1970 Corvette: Service Bulletin: 1970 Corvette Folding Top Material Interference with Lid Pin Support

Source: Chevrolet Dealer Service Technical Bulletin

Bulletin No: 70-T-46

Date: Oct. 27, 1970

FIGURE 1

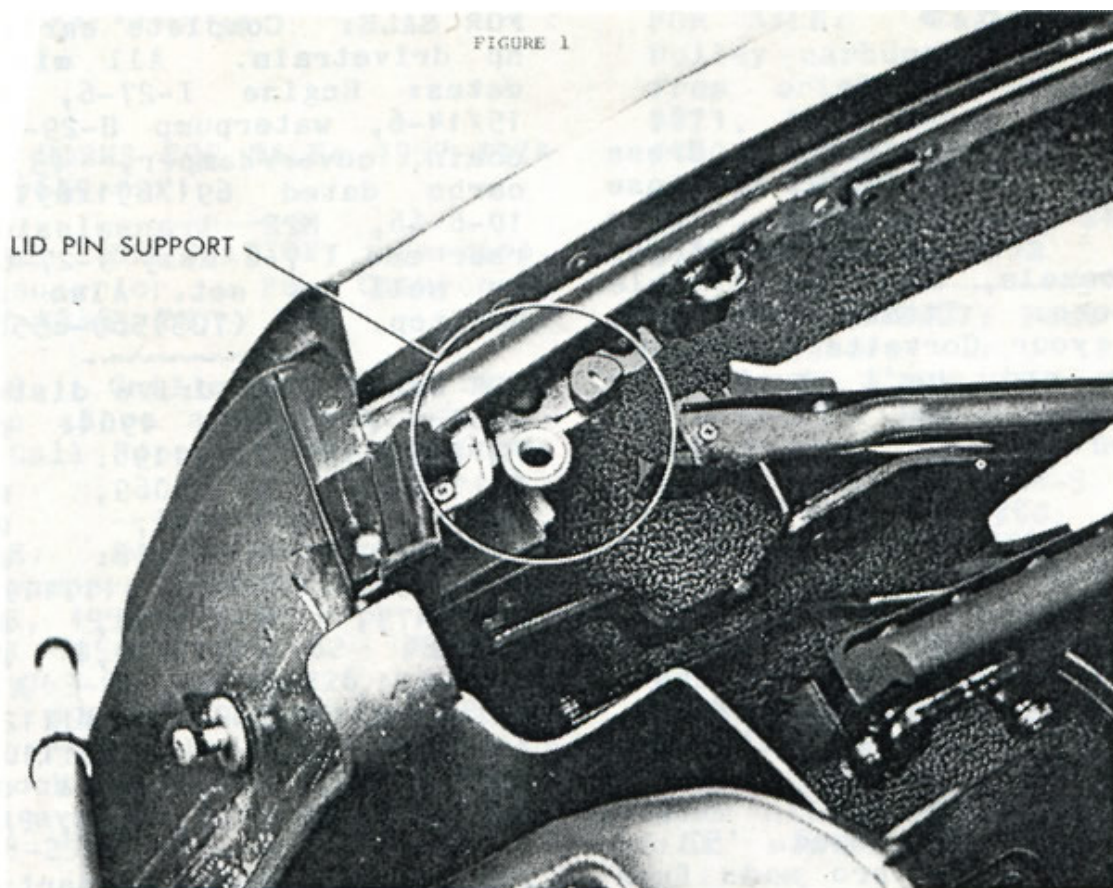
1970 Corvettes assembled prior to Serial Number S400748 may have interference between the folding top material and the top compartment lid pin support. This interference may result in damage to the folding top material.

Vehicles built prior to the above serial number, should be inspected and if interference exists, the top compartment lid pin support should be reworked using the following procedure:

1. Remove the lid pin support. (See Figure 1).
2. Grind 3/8" x 3/4" off the inboard edge of the support. (See Figure 2).
3. Reinstall the lid pin support and inspect to insure adequate clearance exists between the folding top material and the support.

FIGURE 2

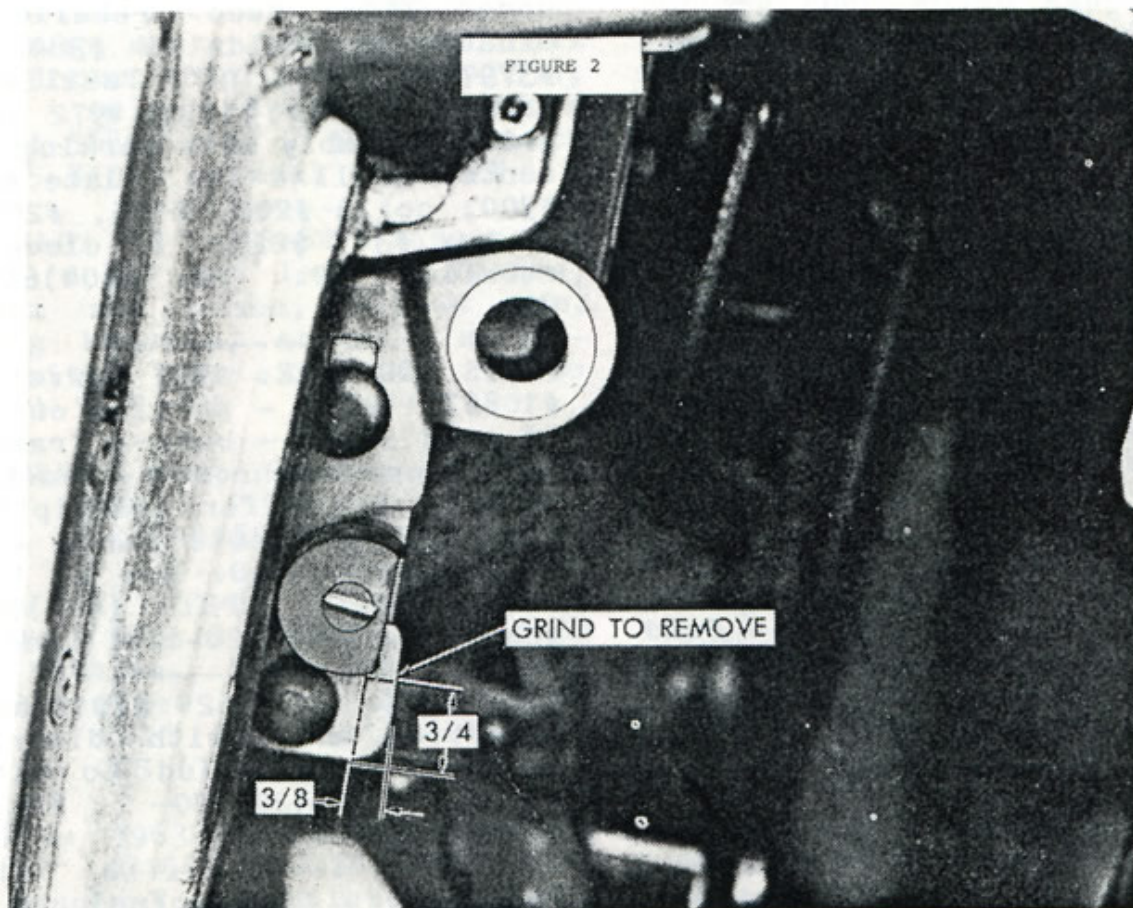
GRIND TO REMOVE
